To: All RedMax Distributors and Dealers
Subject: New Part Numbers of Fuel related parts for 2012 Models.

From 2012 production models, all of fuel pipes, tanks, caps and packings must comply with new EPA emission regulation (40CFR Part 1060).

Chain Saws (except GZ380-16, G5300 and GZ7000)

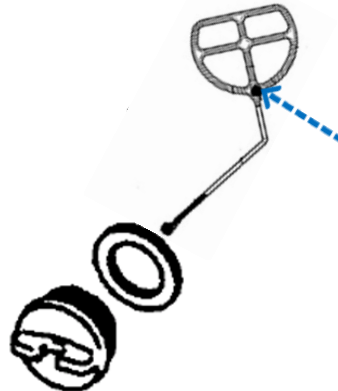
New Part has **"EPA-KEP-002"** mark on fuel line.
 (Old part has no mark)

New Part has **Black Dot** on retainer.
 (Old part has no mark)

Other Models (except BC280, BT280, HB281, BCZ350S and CHT220)

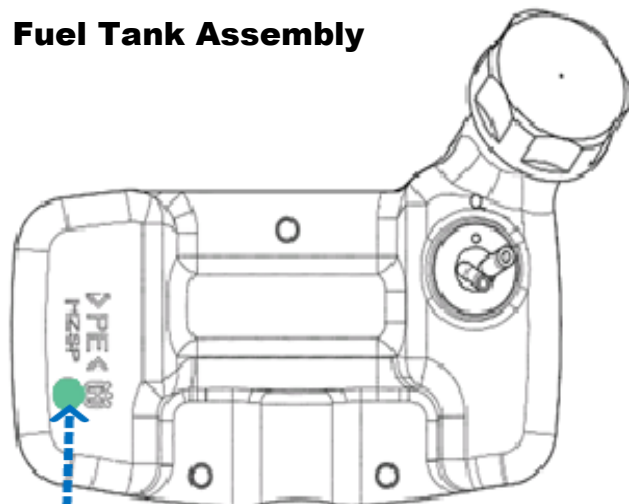
New Part has **"EPA-KEP-001"** mark on fuel line.
 (Old part has no mark)

New Part has **Green Dot at arrowed location** .
